Proposal for amendments to Regulation No. 43 (safety glazing)

The modifications to the current text of the Regulation are marked in bold or strikethrough characters.

A. PROPOSAL

"Rigid plastic windscreens

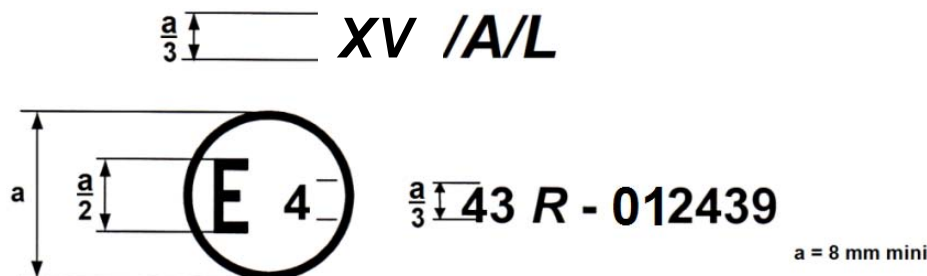
Annex 2, insert the following new paragraphs at the end of the Annex:

The above approval mark affixed to a rigid plastic windscreen shows that the component concerned has been approved in the Netherlands (E 4) pursuant to Regulation No. 43 under approval No. 012439. The approval number indicates that the approval was granted in accordance with the requirements of Regulation No. 43, as amended by the 01 series of amendments.
